North Eastern Regional Power Committee

Sub: 74वीं संरक्षण समन्वय उप-समिति (पीसीसी) बैठक का कार्यवृत्त/ Minutes of 74th Protection Coordination Sub-Committee (PCC) Meeting

74th Protection Coordination Sub-Committee Meeting

Date: 16/12/2024 (Monday)

B.7 Grid Disturbance in Lumshnong area of Meghalaya on 15-11-2024:

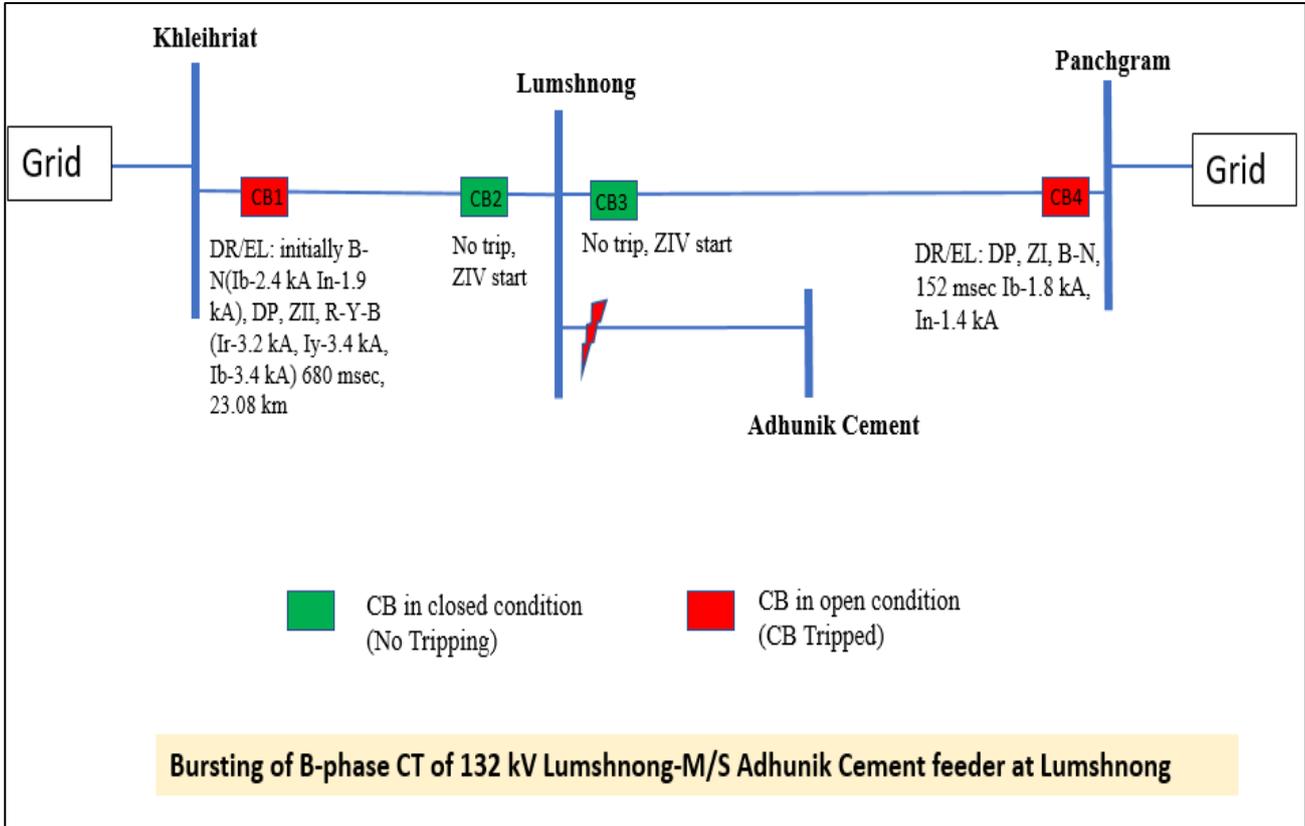
- For 132 kV Lumshnong-Panchgram line, B-N fault initiated at 22:13:34.511 Hrs and cleared within 152 msec on ZI from Panchgram end. There was no tripping from Lumshnong end (ZIV pickup)

- For 132 kV Khleihriat-Lumshnong line, B-N fault initiated and after 186 msec, fault current disappeared. Again after 86 msec, B-N fault reappeared and first converted into Y-B-N fault and then into R-Y-B fault which was cleared within 680 msec on operation of DP, ZII. There was no tripping from Lumshnong end (ZIV pickup)

- Fault was in 132 kV Lumshnong-M/S Adhunik Cement feeder due to bursting of B-ph CT at Lumshnong which was not cleared from Lumshnong end causing tripping of healthy 132 kV Khleihriat-Lumshnong line & 132 kV Lumshnong-Panchgram line.

- Tripping of 132 kV Panchgram-Lumshnong line on ZI from Panchgram end seems to have overreached. AEGCL needs to check/review the distance setting to avoid overreaching of ZI.

- Time drift of 1 Hour observed at Khleihriat end for 132 kV Khleihriat-Lumshnong line which need to be sync with GPS by MePTCL.

- Share the root cause and remedial measures taken.
- Furnish the reason of non-operation of protection system at Lumshnong end for 132 kV Lumshnong-M/S Adhunik Cement feeder.
- Check/review the distance protection setting to avoid overreaching of ZI.
- Rectify the DR time drift at Khleihriat end.

1. MePTCL informed that there is no distance protection of the Adhunik cement feeder and the tripping command was issued for the fault I 100 ms on O/C high set pick up. However, he added, that the fault continued to be fed because of insulator flash-over caused by accumulation of dust on the insulator.
2. PGCIL suggested that to address the problem of dust accumulation on the insulators, RTV coating on the insulators may be done. Forum opined that MePTCL to carry out RTV coating on the vulnerable insulators to reduce such tripping in future.
3. Regarding Z1 operation at Panchgram, AEGCL assured to look into the matter.

B.9 Grid disturbance in Umrangsho area of Assam on 24-11-2024:

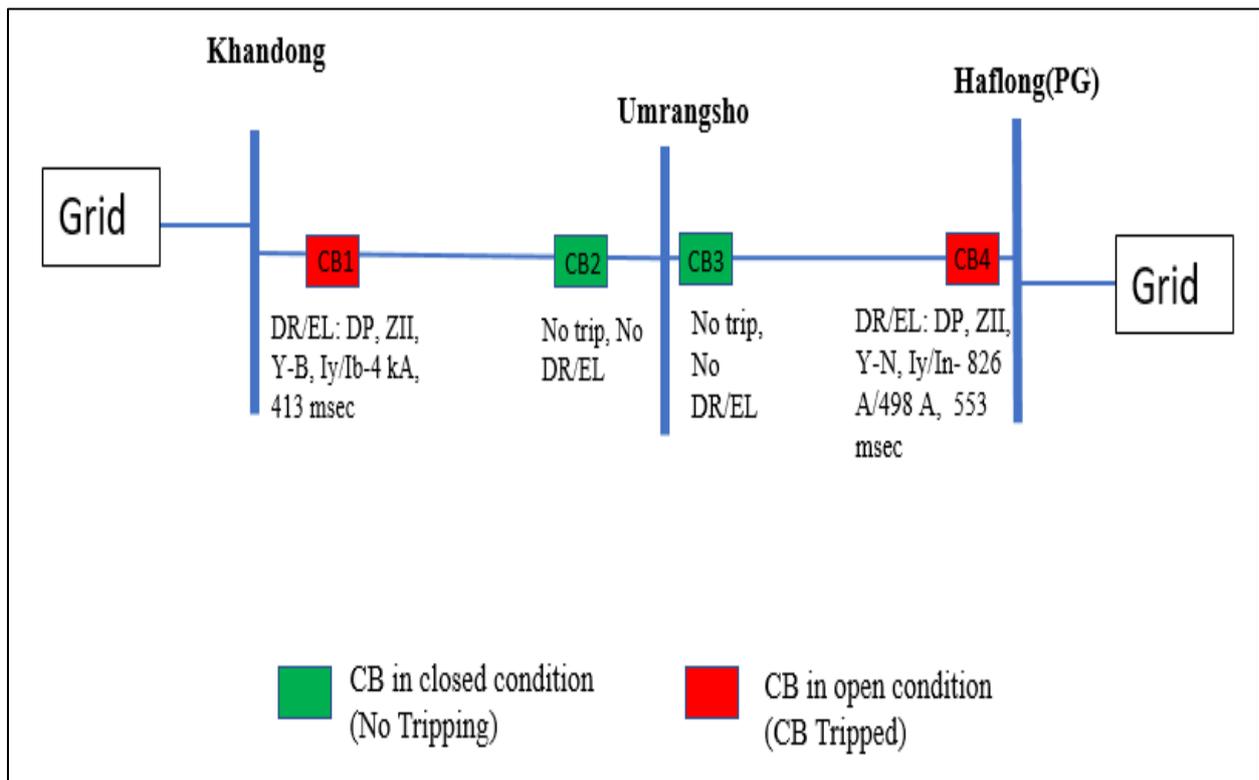
As per DR analysis of 132 kV Khandong-Umrangsho line, Y-B fault (Iy-4 kA, Ib-4 kA) initiated at 04:55:26.146 Hrs and cleared within 413 msec on operation of DP, ZII from Khandong end. There was no tripping from Umrangsho end.

As per DR analysis of 132 kV Haflong(PG)-Umrangsho line, Y-N fault (Iy-826 A In-498 A) initiated at 04:55:24.959 Hrs and cleared within 553 msec from Haflong(PG) end on operation of DP, ZII. There was no tripping from Umrangsho end.

- Update the reason of non-tripping of Umrangsho CB for 132 kV Haflong(PG)-Umrangsho line.
- Submit DR/EL at Umrangsho end for both the lines for proper analysis of the event.

AEGCL informed that jumper of Haflong feeder at Umrangsho end snapped which caused the fault. He added that CB3 was non-operational and the fault could not get cleared timely. Further he informed that the CB would be checked in the upcoming shutdown of the line.

Forum advised AEGCL to provide DR/EL and root cause analysis report by next PCCM.

B.10 Grid Disturbance in Monarchak and Rokhia areas of Tripura on 06-12-2024:

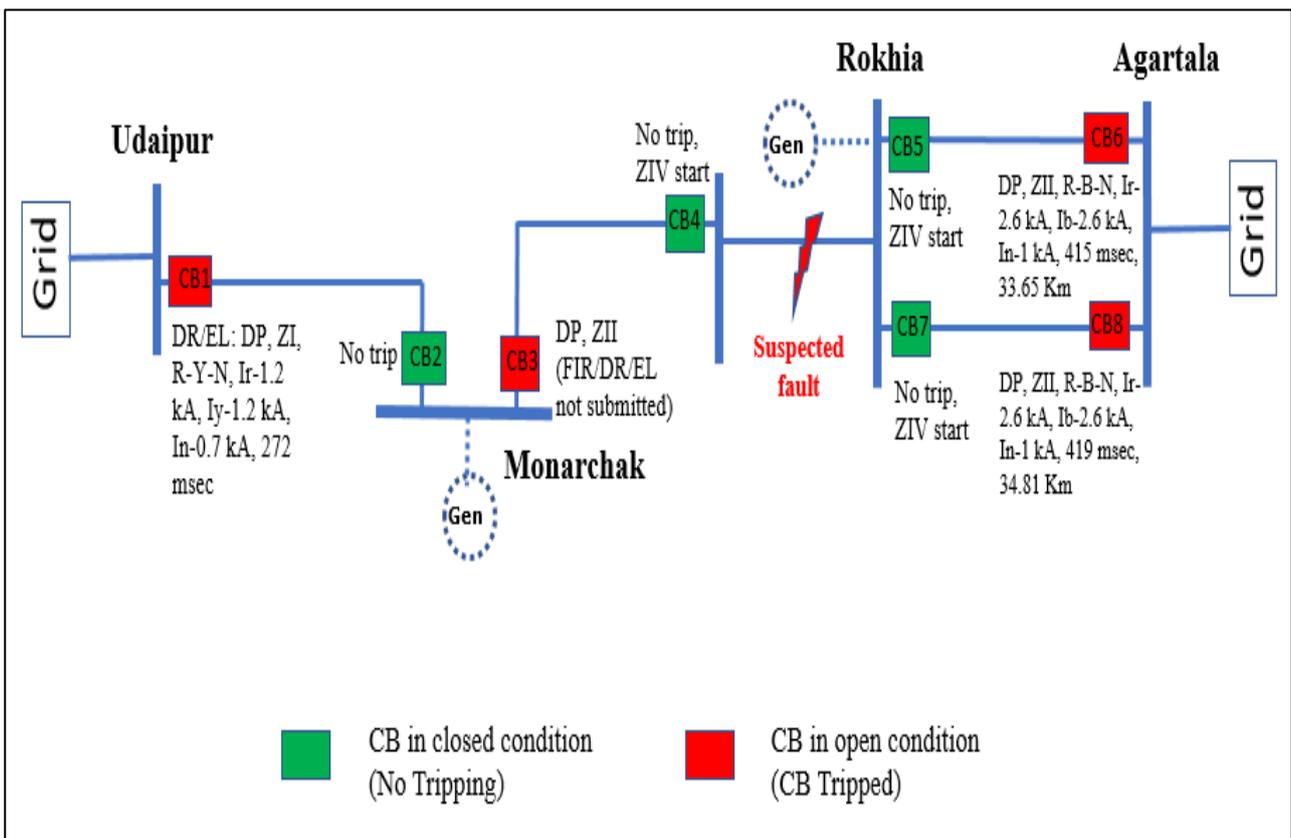
As per DR analysis, R-B-N fault initiated at 13:05:19.698 Hrs and cleared within 415 msec from Agartala end on operation of DP, ZII. No tripping from Rokhia end (ZIV start)

132 kV Monarchak-Rokhia line tripped on ZII from Monarchak (No FIR/DR/EL submitted). There was no tripping from Rokhia end (ZIV start)

- Suspected fault in 132 kV Rokhia-Rokhia link feeder which was not cleared leading to tripping of healthy lines 132 kV Monarchak-Rokhia line & 132 kV Agartala-Rokhia D/C lines on ZII from remote ends.
- At the same time, 132 kV Monarchak-Udaipur line tripped on ZI from Udaipur end which seems unwanted.
- At the same time, AGTCCPP Unit-2 & 6 tripped which seems to be misoperation.

- Share the root cause and remedial actions taken.
- Update the status of installation of Line differential protection in 132 kV Rokhia-Rokhia Link feeder.
- Furnish the reason of tripping of 132 kV Monarchak-Udaipur line for fault in 132 kV Rokhia S/S.
- Reason of tripping of AGTCCPP Unit-2 & 6.
- Submit detailed report in compliance with IEGC-23
- Submit DR/EL within the specified timeline as per IEGC-23.

1. TSECL informed that fault was near the main bus at Rokhia S/S as a CCTV cable snapped and came near the bus and flashover occurred.
2. Regarding the Line Differential Protection on the Rokhia-N.Rokhia link, Tripura updated that the commissioning is underway and would be completed shortly.
3. ***NERPC stated that 132 kV generating station should have provision of Double Main Bus scheme to ensure necessary reliability. Forum urged the all the utilities to take necessary action in this regard.***
4. Regarding tripping of AGTCCPP units 2 and 6, NEEPCO informed that the tripping occurred due to relay maloperation. He further informed that the relay panels were old and replacement of the relays, by numerical ones, was being planned.
5. *Forum advised Tripura to provide analysis report on zone 1 operation at Udaipur for Monarchak line.*

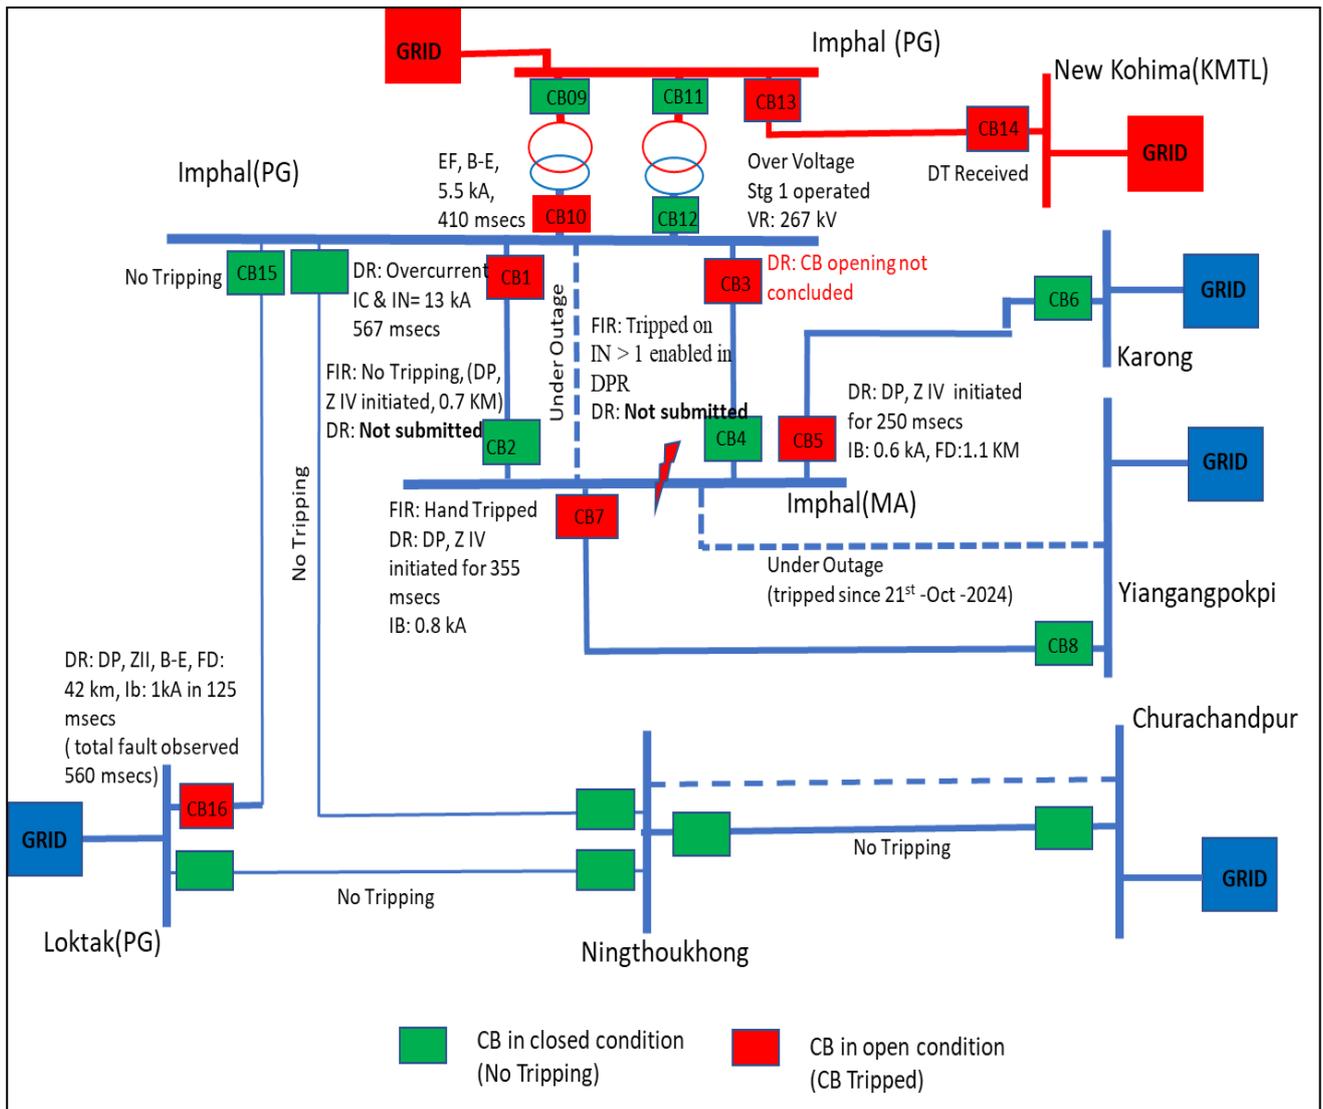
Additionally, tripping of 400/132 kV, 315 MVA, ICT I at Imphal (PG), 132 kV Imphal (PG) - Loktak Line and 400 kV Imphal(PG) - New Kohima 1 Line observed during the time.

As per event analysis based on the DR & EL, DP, ZIV initiated at Imphal (Yurembam) for Imphal (PG) 1 line, Karong line and Yaingangpokpi 1 line indicates that fault location is in the Imphal (Yurembam) Substation. The fault persisted in the system for 560-567 msec.

1. Manipur stated, regarding the root cause of the fault, that fault initiated due to B-phase Bus jumper snapping at Yurembam SS, however further investigation are underway to ascertain the correct root cause of the fault.

C.5 Grid Disturbance in Dibrugarh area in Assam on 29-10-2024:

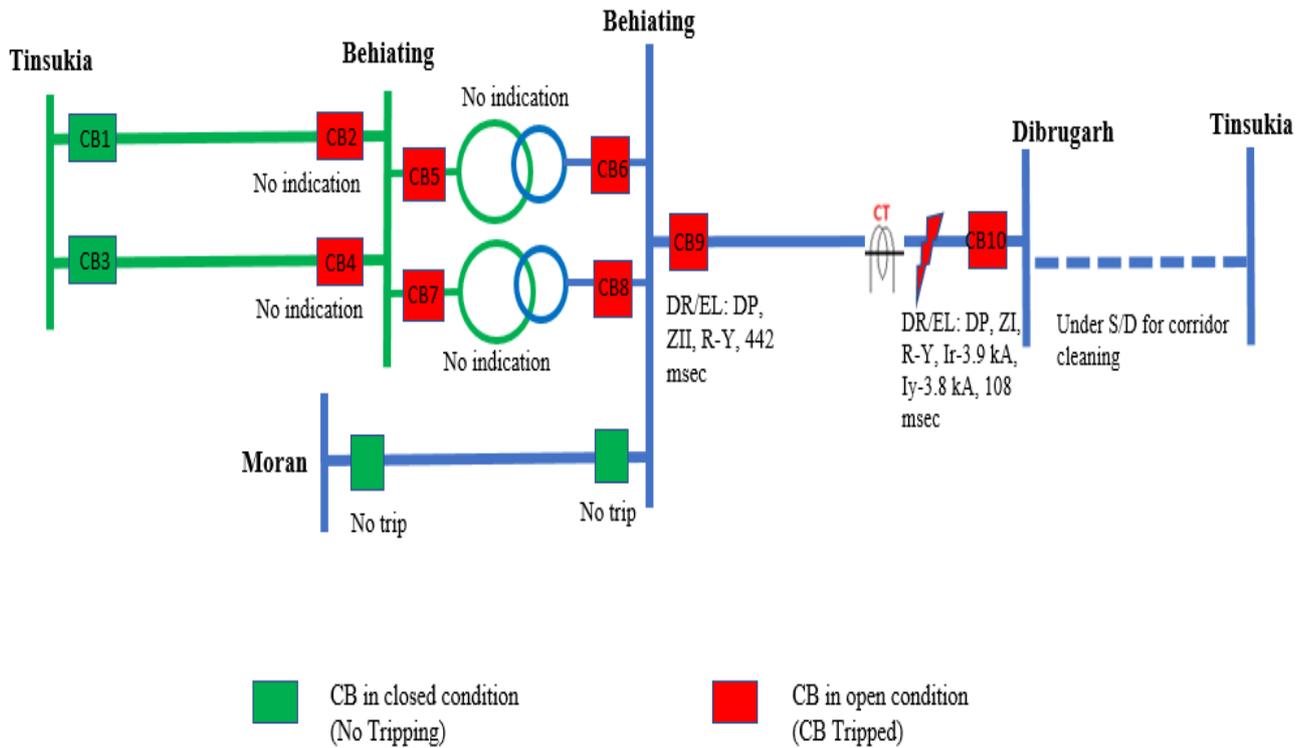
As per DR analysis, solid R-Y phase fault (Ir-3.9 kA, Iy-3.8 kA) in 132 kV Dibrugarh-Behiating line initiated at 09:05:53.331 Hrs and cleared within 108 msec on operation of DP, ZI from Dibrugarh end and within 442 msec from Behiating end on operation of DP, ZII.
